# Denistone Station Upgrade

Determination Report

February 2022

**Figure 3.1 Additional glazing proposed to front entrance of Denistone Station (left as identified in the REF, right, modified design)**

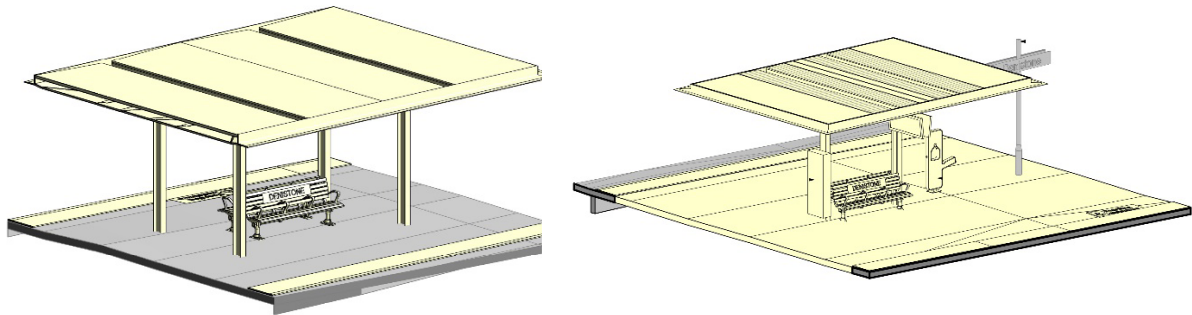
<p>The modified design would include an additional section of glazing at the station entrance.</p>	<p>The modified design would include an additional section of glazing at the station entrance within the vicinity of the proposed rubbish bins (refer to Figure 3.1).</p> <p>The proposed modification would not impact the assessment of potential impacts as presented in the REF due to the minor nature of this modification.</p>
<p>The modified design would include an minor change to the proposed design of the boarding assistance zone canopies on Platform 1/2 and Platform 3</p>	<p>The proposed modification would provide a revised design to the proposed boarding assistance zone canopies through reduced glazing and reduced number of support structures (refer to Figure 3.2).</p> <p>The proposed modification would not impact the assessment of potential impacts as presented in the REF due to the minor nature of this modification.</p>
